**NRC Response to Facility Comment on the
March 2017 Generic Fundamentals Examinations**

FACILITY: Monticello
EXAM: BWR Form A/B
QUESTION: BWR 15/29 (Also applies to PWR 14/28)

Subject: March 2017 Generic Fundamentals Examination Comment

Figure 1-<http://physics.info/electric-resistance/>

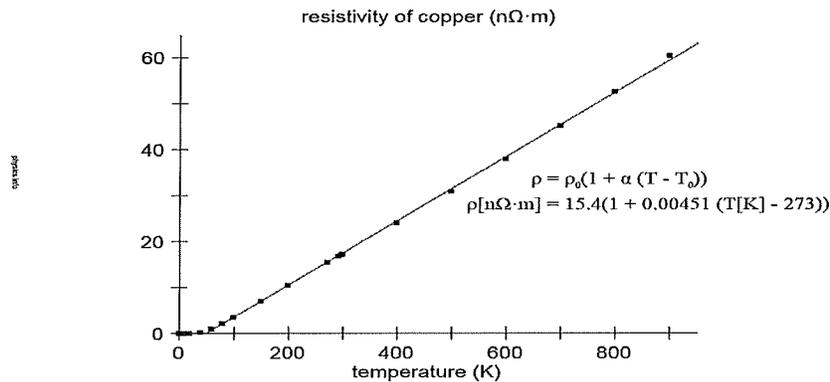
The purpose of this letter is to submit a comment to the March 2017 Generic Fundamentals Examination (GFE), question 15 of form A. Specifically, none of the answers appear to be a viable choice, when the temperature coefficient of resistance for the conductor is considered.

The figure below shows the relationship of temperature and the resistance of copper.

Therefore, since $R_2 > R_1$ the correct answer should be some value more than 280 F as the temperature rise would be greater than 200 F.

However, the facility comment correctly asserts the answer should be greater than 280°F because R will increase as stator temperature increases, thereby causing a greater increase in P. Using the

Therefore, the question will be deleted.
